**ADDENDUM NO. 1
FOR
HOUSTON COMMUNITY COLLEGE SYSTEM
IFB 16-04 HCC REROOFING at KATY CAMPUS**

PROJECT NO. 20150720-41
DATE: 12/04/15
DRAWN BY: CB
ADDENDUM #1

PROJECT FOR :
HOUSTON COMMUNITY COLLEGE
NORTHWEST CAMPUS
KATY CAMPUS
1550 FOX LAKE DRIVE
HOUSTON, TEXAS

1 OVERALL ROOF PLAN

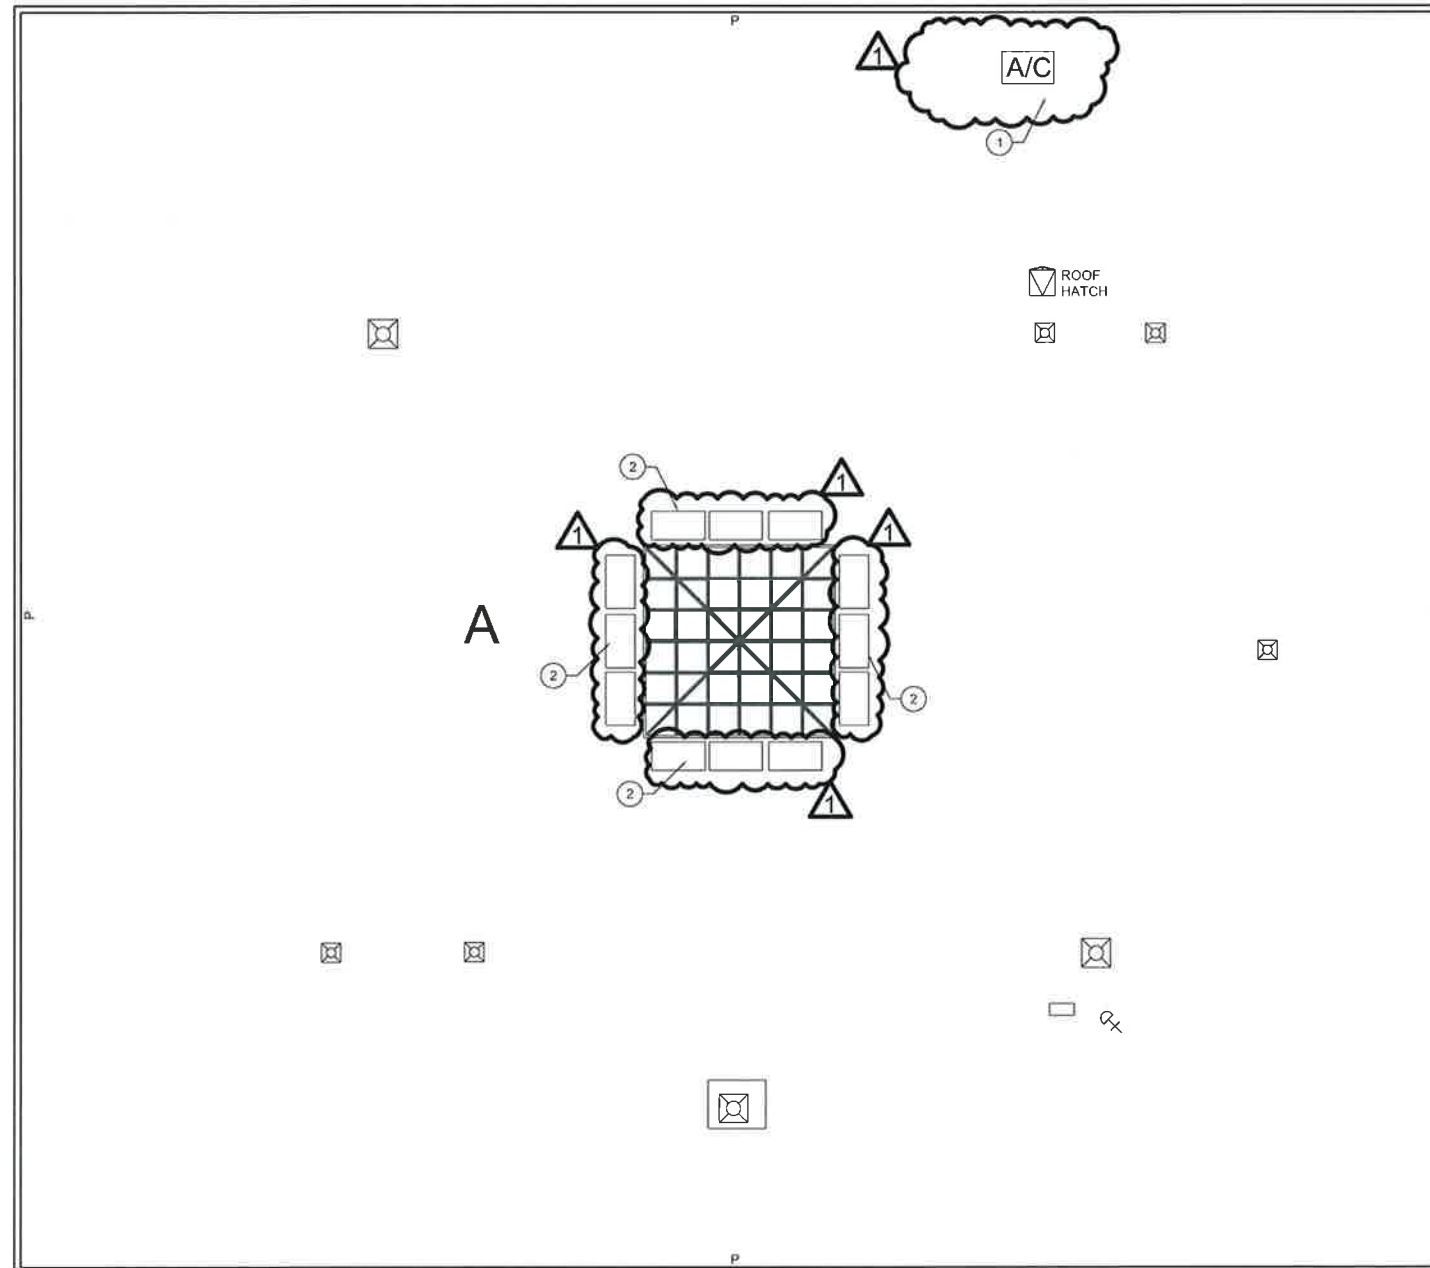
6. Contractor is to remove the existing HVAC unit as indicated on the revised roof plan. Remove existing curb install new metal decking and secure per ASCE 7 guidelines.

7. Contactor is to remove twelve (12) existing curbs around the skylight as indicated on the revised roof plan, install new metal decking and secure per ASCE 7 guidelines.

- 1. REMOVE THE EXISTING HVAC UNIT AND CURB FROM THE ROOF. CONTRACTOR IS TO INSTALL NEW METAL DECKING AND SECURE PER ASCE 7 GUIDELINES. HVAC UNIT IS TO REMAIN PROPERTY OF HCCS.
- 2. REMOVE THE EXISTING 12 CURB UNITS ALONG EACH SIDE OF THE EXISTING SKYLIGHT. CONTRACTOR IS TO INSTALL NEW METAL DECKING AND SECURE PER ASCE 7 GUIDELINES.
